Upper South Creek Advanced Water Recycling Centre

Submissions Report – project amendments

April 2022

Figure 5-1 Biodiversity impacts from the Kemps Creek realignment

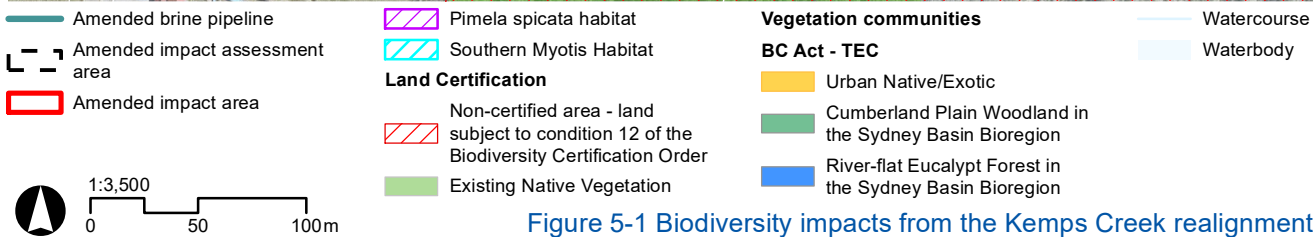
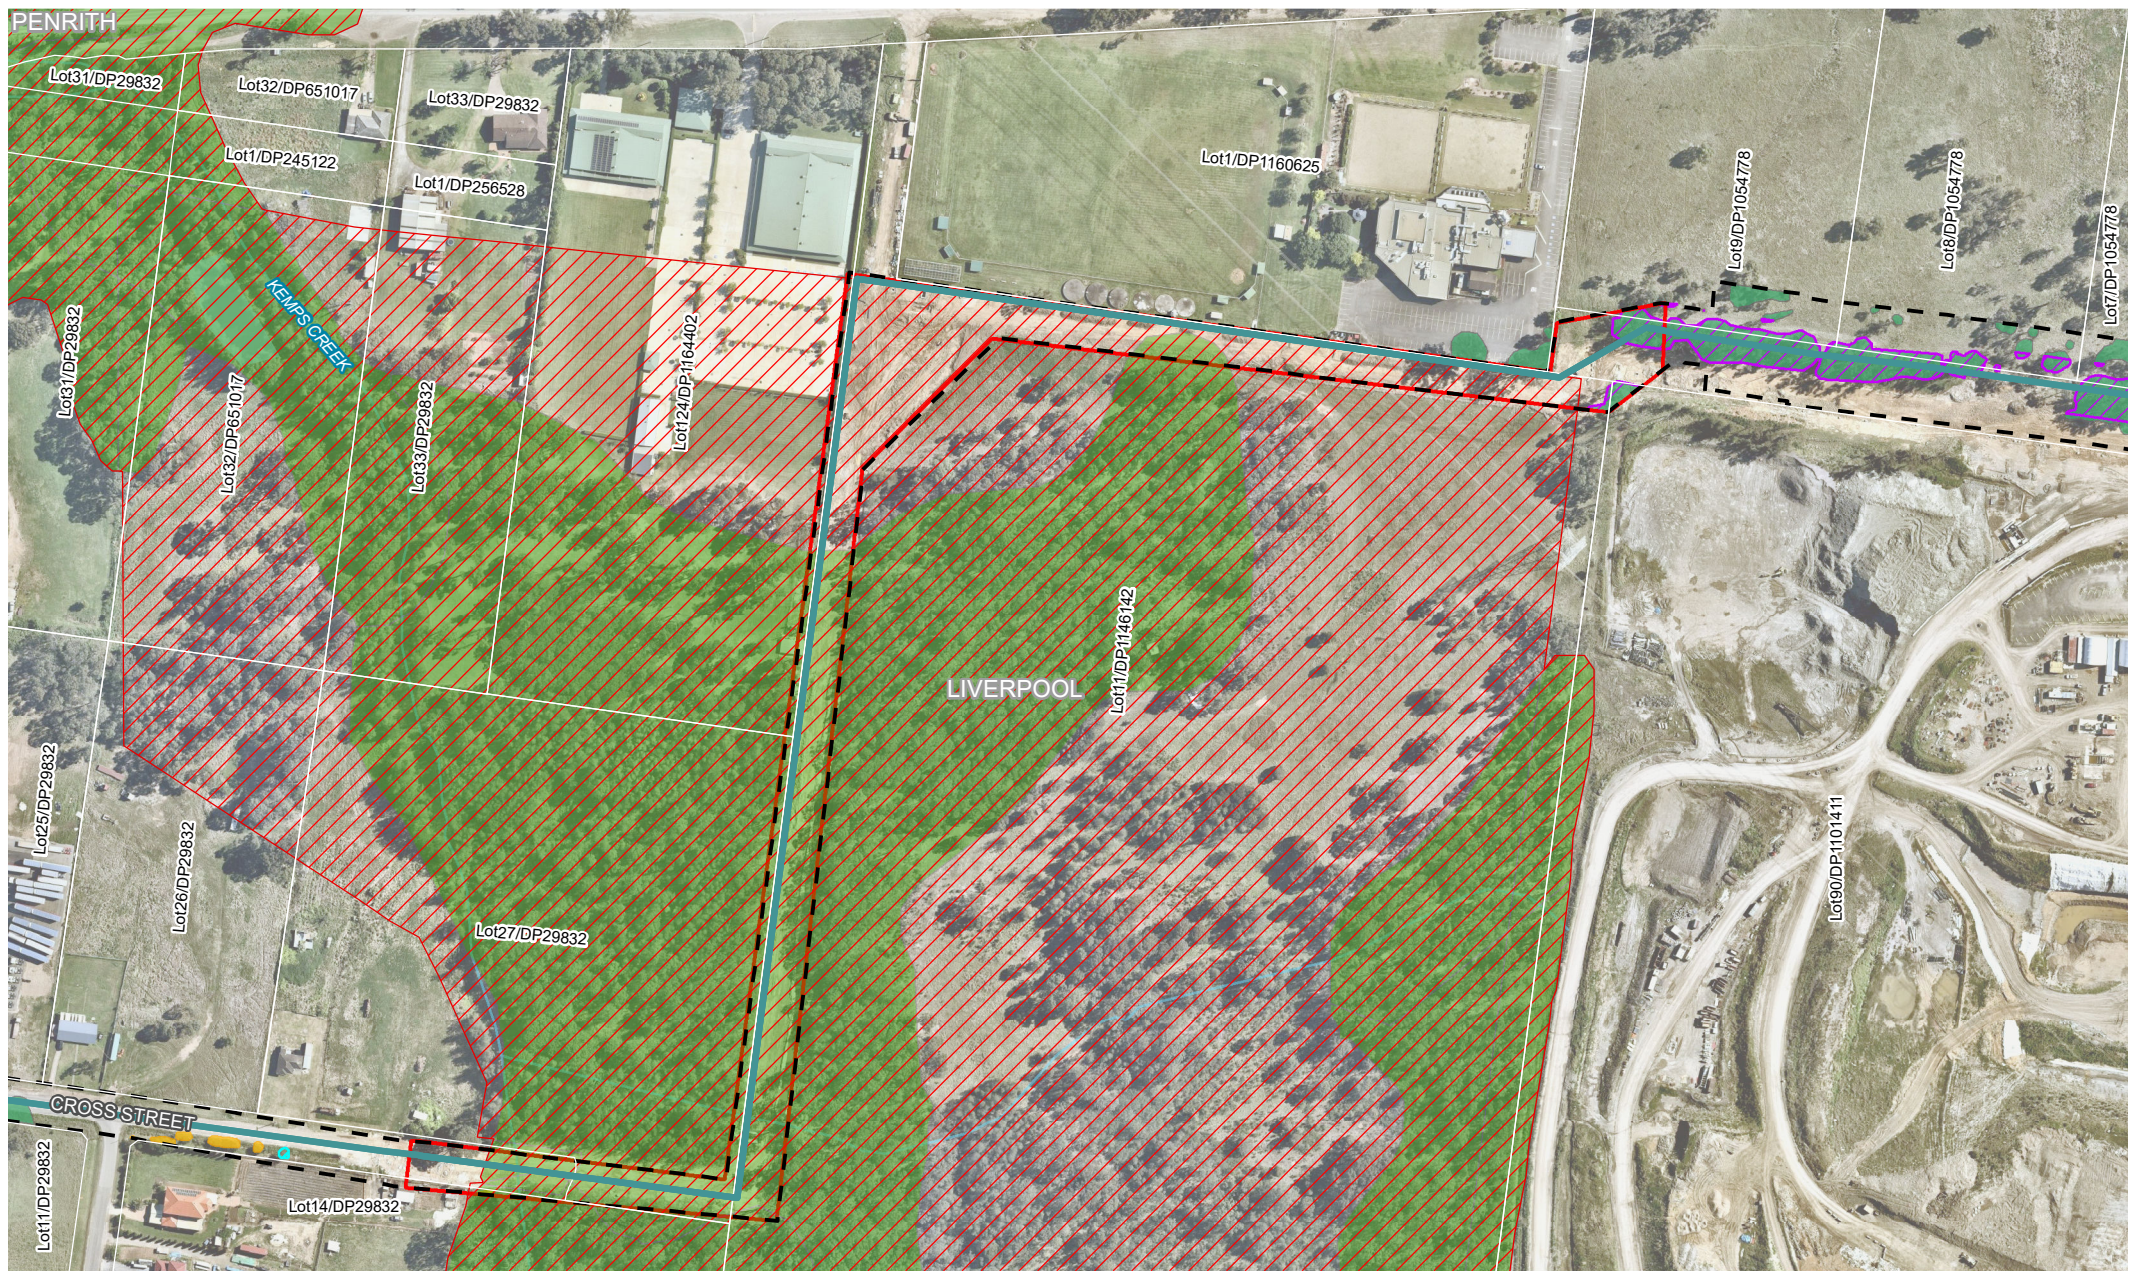
Submissions Report should include ENV on maps as well as Relevant Biodiversity Measure (RBM) 12.	<p>Sydney Water has included Figure 5-1 below as an update to Figure 7-5 in the project's Amendment Report (Sydney Water, 2022b), to show ENV as well as RBM 12.</p>
<p>Concern that rehabilitation is proposed to pre-existing condition given current pre-existing condition of the corridor is a fully cleared site as a result of another Sydney Water project.</p> <p>DPE EH requires a separate Rehabilitation Management Plan be prepared specifically for the red-hatched lands to revegetate and restore the corridor to its condition prior to the clearing undertaken for another Sydney Water project. The plan should include the requirements detailed in G05 and will need to be approved by DPE EH.</p>	<p>Sydney Water confirms that it intends to rehabilitate the area cleared as a result of another Sydney Water project on the basis that the pre-existing condition is native vegetation. This means that the native vegetation measures in management measure G05 in Appendix B of the Submissions Report will apply. The rehabilitation will be completed after construction of the brine pipeline.</p> <p>Sydney Water will include a specific section for rehabilitating the red-hatched lands as part of the Rehabilitation Management Plan in management measure G05. Sydney Water considers that approval requirements for any management plans are best captured by DPE through the project's conditions of approval. Sydney Water also notes that the land in question is not currently owned by</p>

Issue raised	Response
	DPE and that rehabilitation will also need to be in consultation with the landowner.
